TRAILS AT OVERLAND RANCH - SITE PLAN 1

SITE PLAN

COVER SHEET

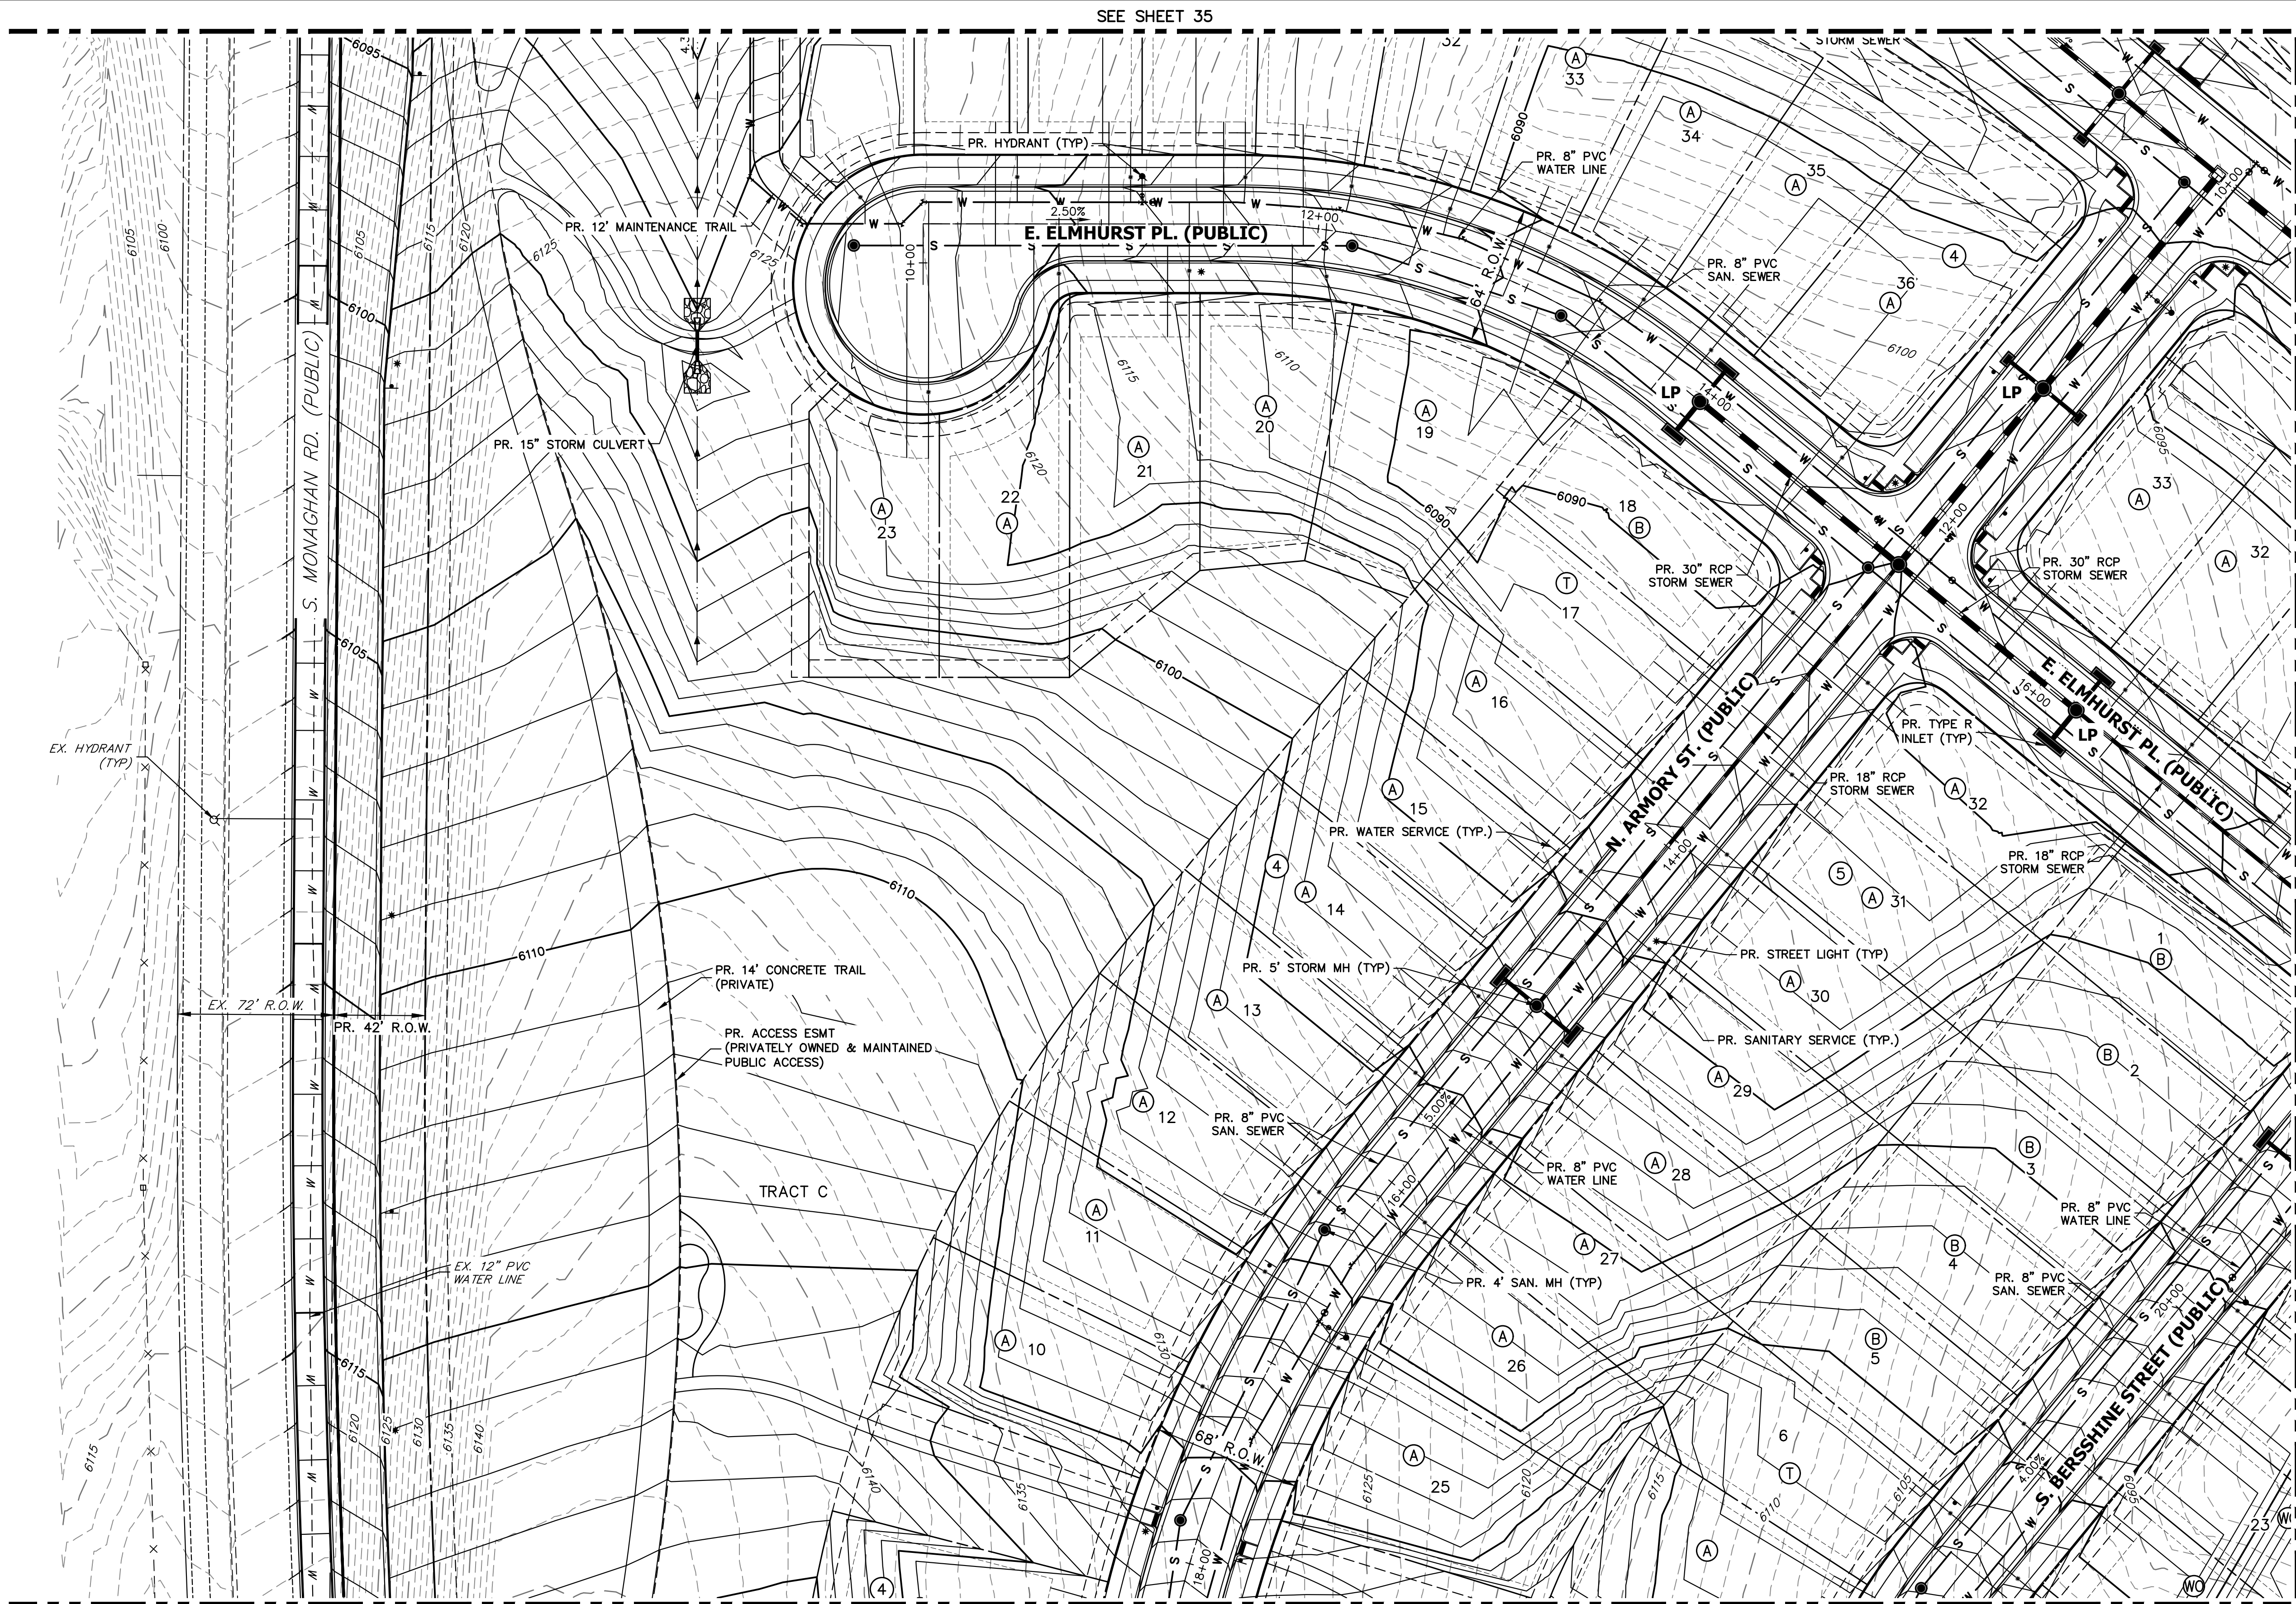
Dead-end water lines supplying fire hydrants must maintain a minimum available residual pressure of twenty (20) psi for firefighting purposes. No more than one (1) fire hydrant is allowed off of a dead-end water line extension. The water line supplying the dead-end line must be supplied from a looped system. Any dead-end water line supplying a fire hydrant that exceeds one hundred fifty (150) feet require calculations to be shown on the utility sheet of the civil drawings. The calculation provided must reflect no less than a twenty (20) psi residual water pressure. Note: If the 20 psi residual pressure cannot be met, then a looped water supply will be required to support the needed fire hydrant.

- Indicate the sheet number that reflects the hydraulic calculations that validate that the fire hydrant at the end of this dead-end water line will provide a 20 psi minimum pressure.

Provide calculation for dead-end fire hydrant. See note provided.

Check with Aurora Water if 90 degree bend on a fire hydrant lateral is acceptable.

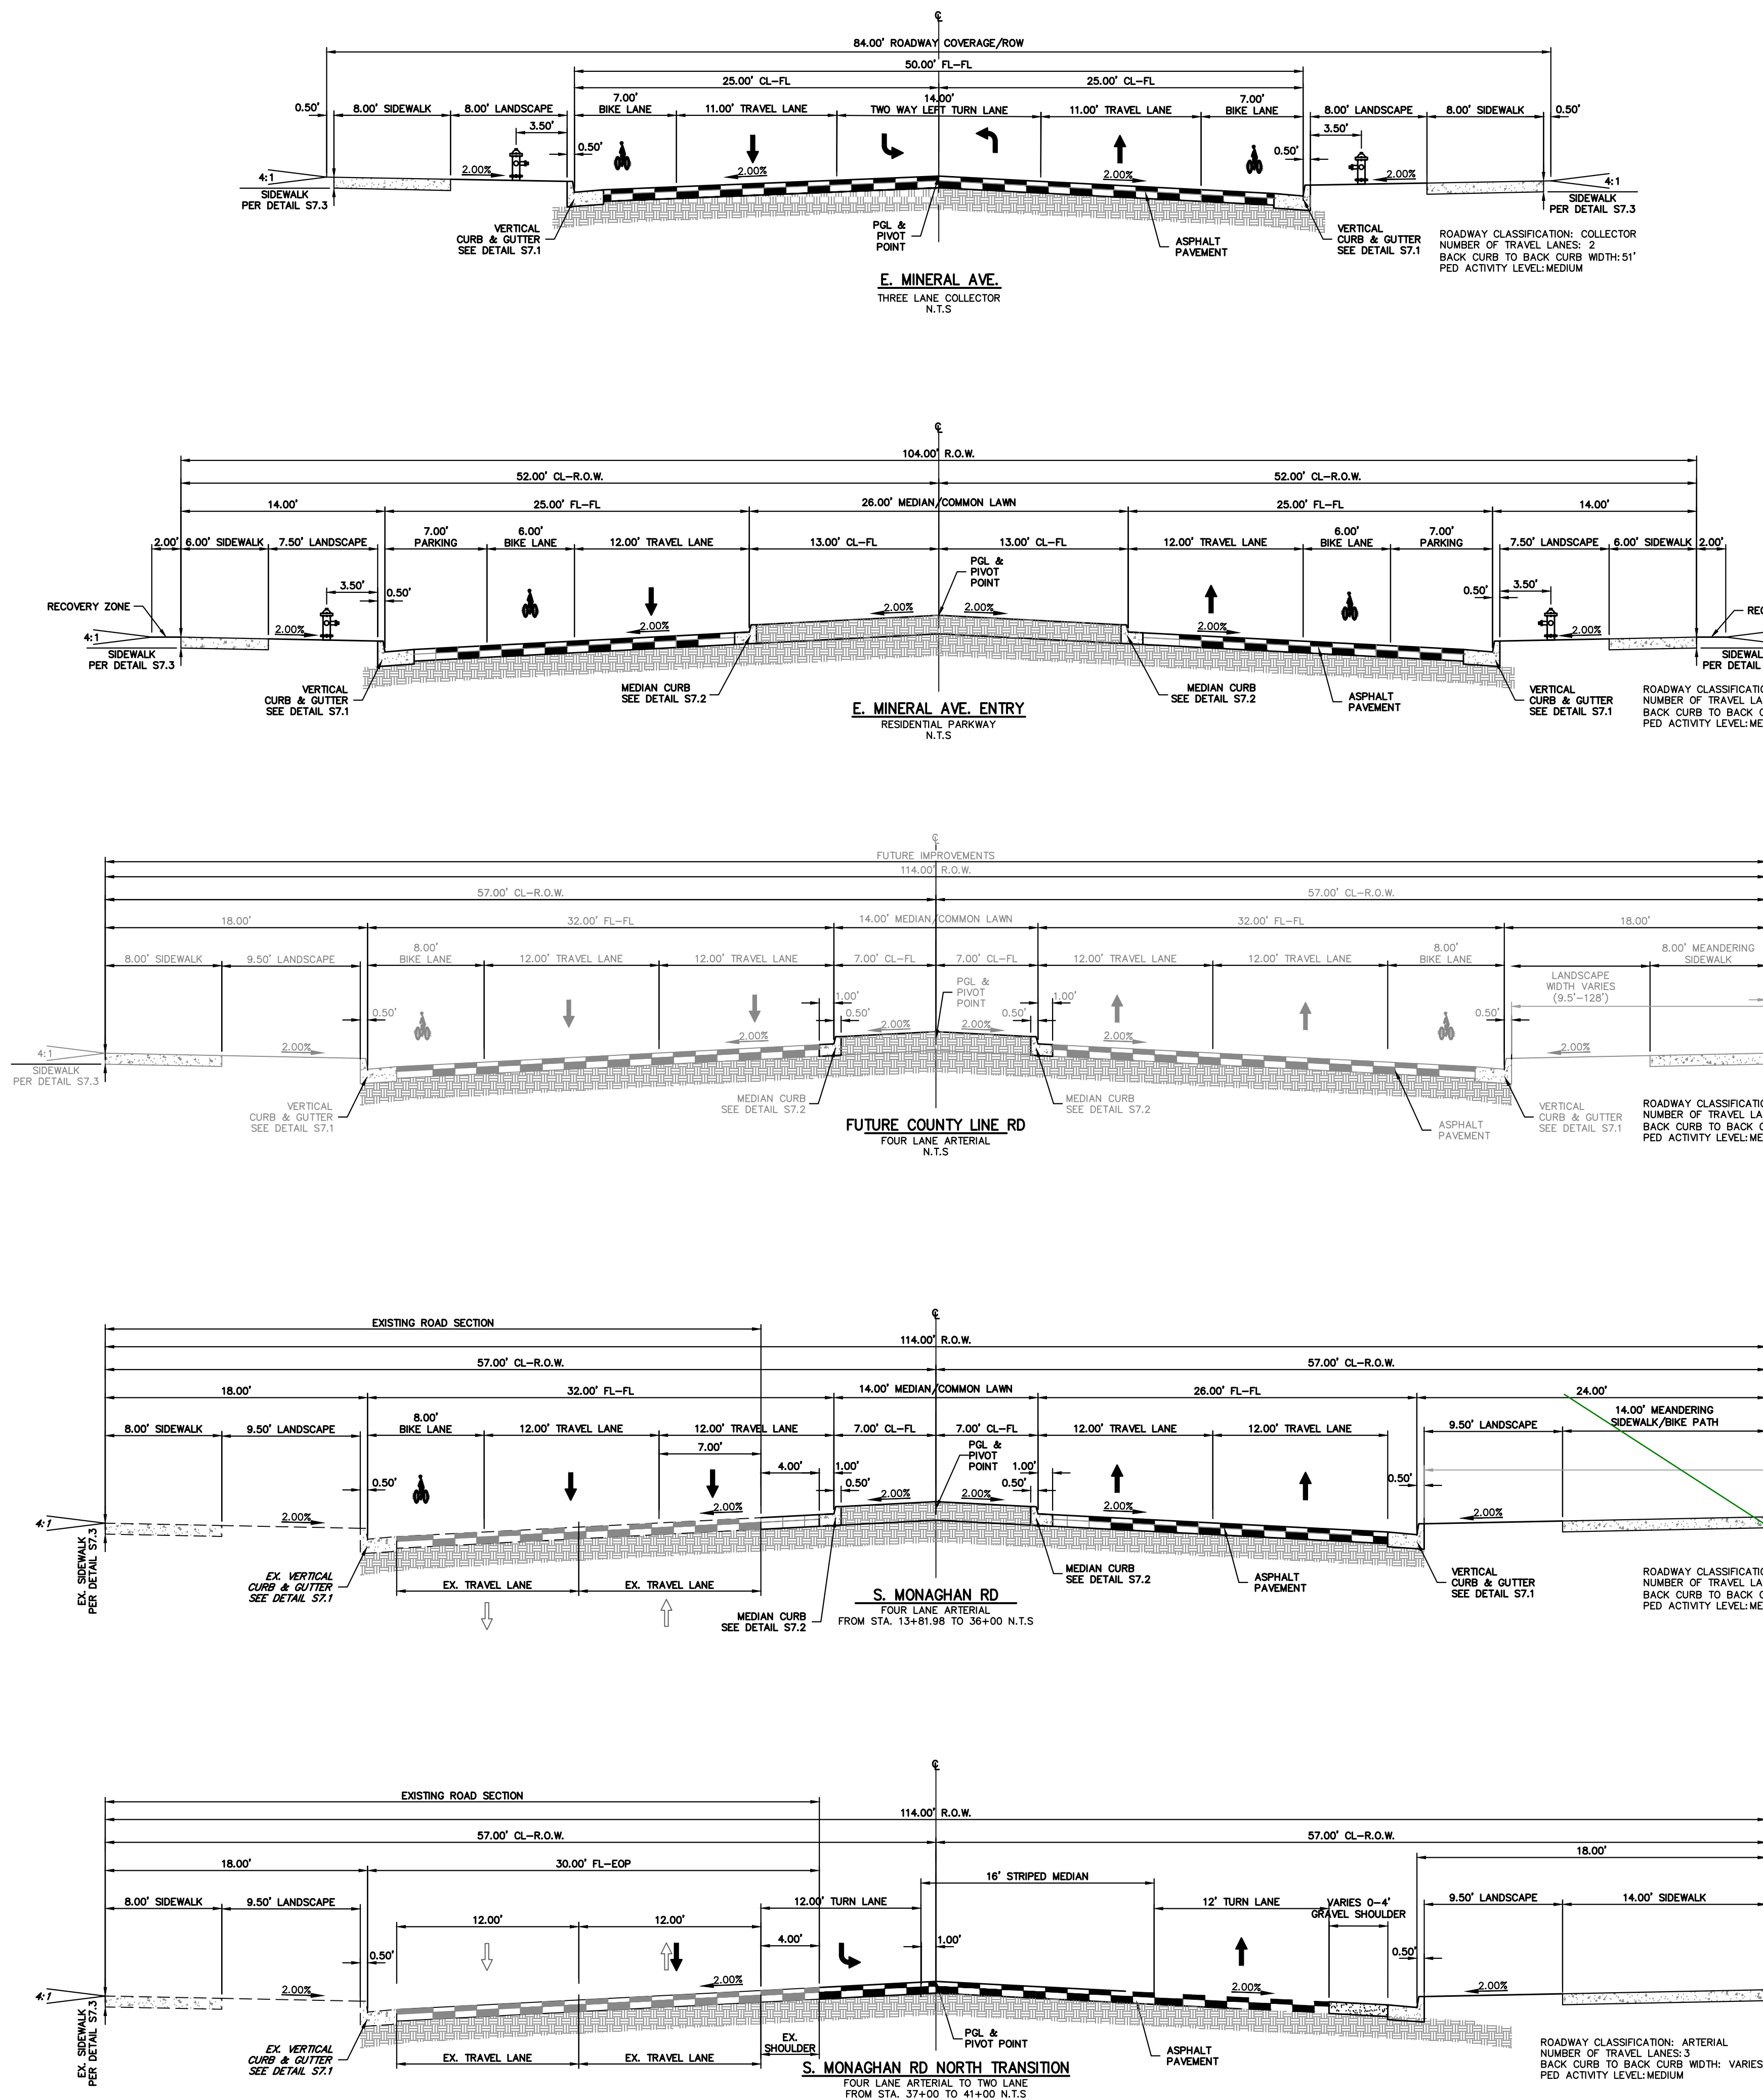
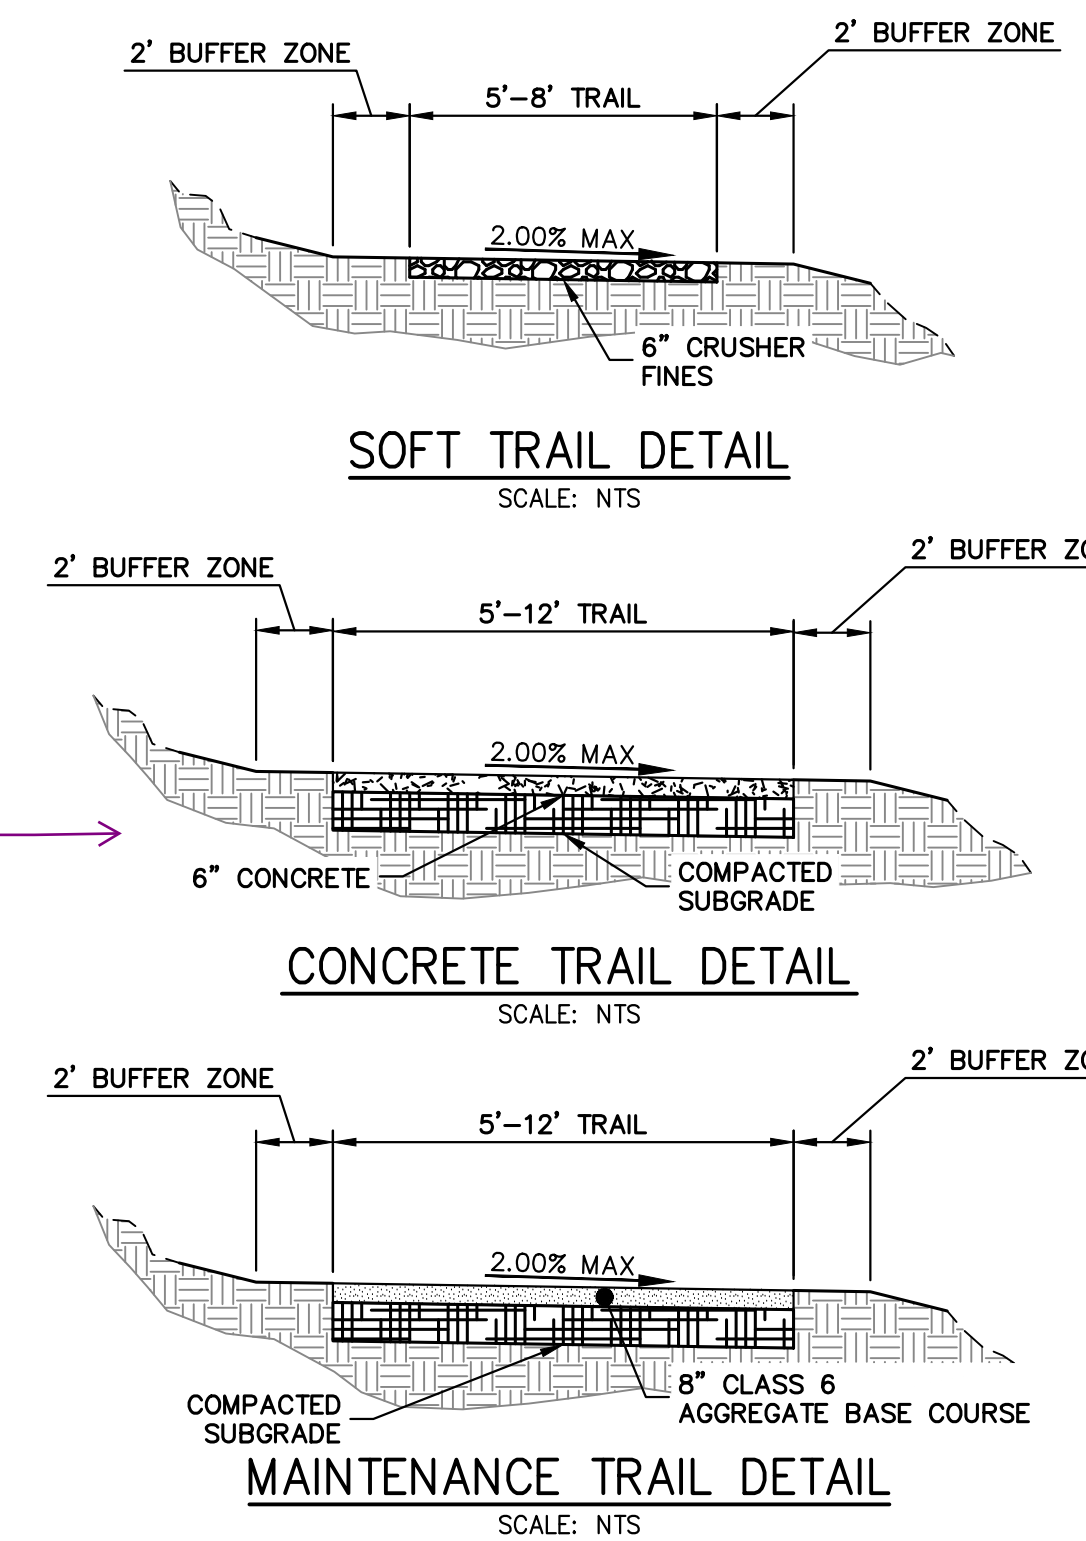
Management staff is discussing the section proposed for County Line Rd. and the sidewalk requirement will be provided via email as soon as a determination is made about whether the bike lane will remain on the street or be combined with the sidewalk.

RESPONSE:
Section updated to reflect public walk with 30' or less or meander.
